APPLICATION FOR LAND USE CONSISTENCY DETERMINATION  
San Mateo County Airport Land Use Commission  
C/CAG ALUC

Project Name: 40 Airport Boulevard - Residential Project

**Subject:***Application for Land Use Consistency Determination for New Apartment Building at 40 Airport Blvd, South San Francisco*

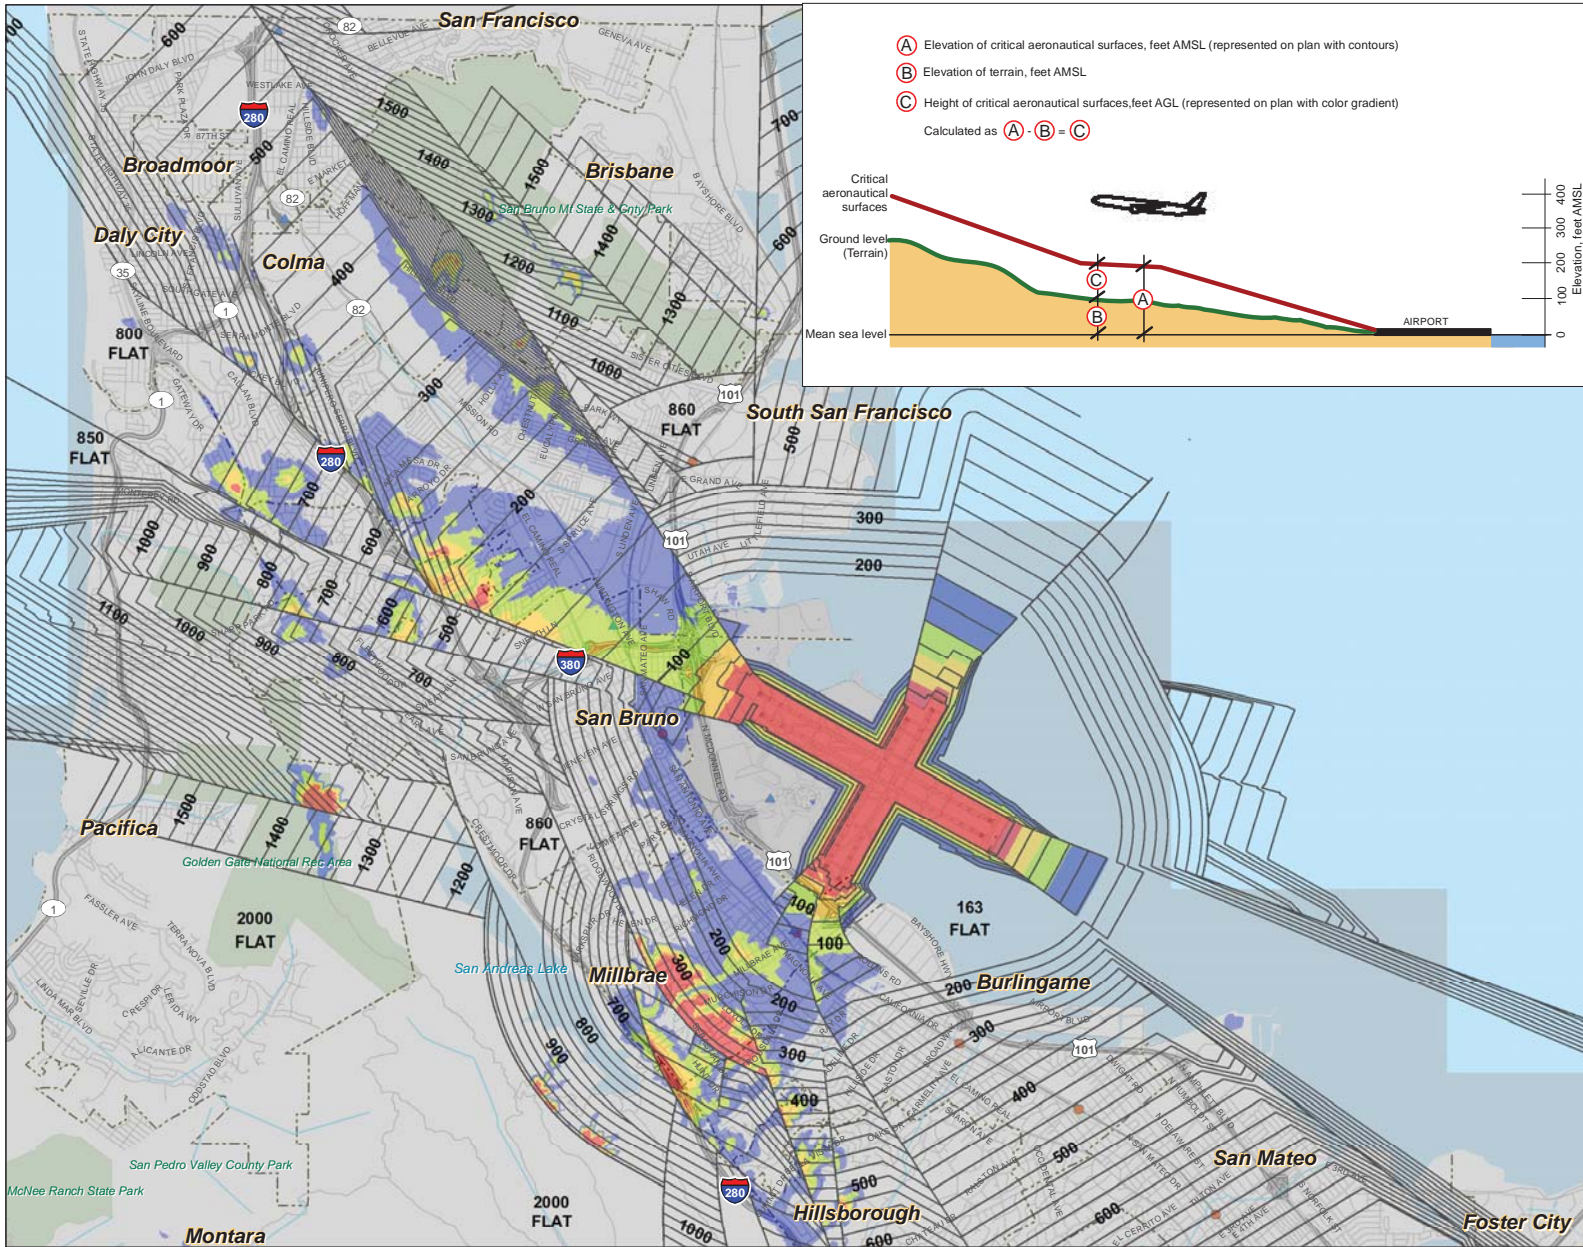
As described in Exhibit IV-17 of the SFO ALUCP (see Attachment), the critical aeronautical surfaces at the Proposed Project location are at an elevation of above approximately 575 feet above mean sea level (AMSL) as defined from the origin of the North American Vertical Datum of 1988 (NAVD88). Given that the ground elevation at the Proposed Project site is at 15.95 feet AMSL (NAVD88) and maximum height of the building is defined as 95.03 feet above ground level (AGL), the top elevation of the structure at 111.03 feet AMSL (NAVD88) would be below the critical aeronautical surfaces and the Proposed Project would not appear incompatible with the Airspace Compatibility Policies of the SFO ALUCP, subject to the issuance of a Determination of No Hazard from the Federal Aviation Administration (see below) for any proposed

The Application for Land Use Consistency Determination Supplemental Information states incorrectly that the criterion for compatibility should be based on the 14 CFR Part 77 imaginary surfaces shown in Exhibit IV-14. As detailed above, the critical aeronautical surfaces are described in Exhibit IV-17. While this does not have a material effect on the analysis, the Project sponsor is advised to cite the correct exhibits and land use compatibility policies in any future submissions.
